Access Compliance Report Public Rights-of-Way (Pedestrian Signals)

ADA ID: 7DCA03CCC87B Signal Type: One Push Button-Non APS **Overall Compliance: No** Severity Score: BTN 1:N/A BTN 2: N/A No BTN: N/A

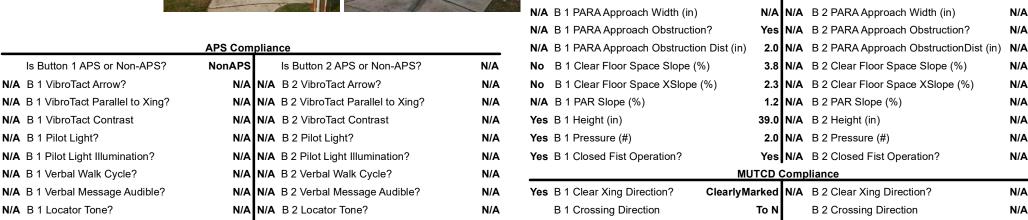
PROW/ADA: TMUTCD 4e.08, R404.2, R404.3, R406.2

Possible Solutions: Replace Signal Push Button With APS Button on New Post. Remove & Relocate Sign.
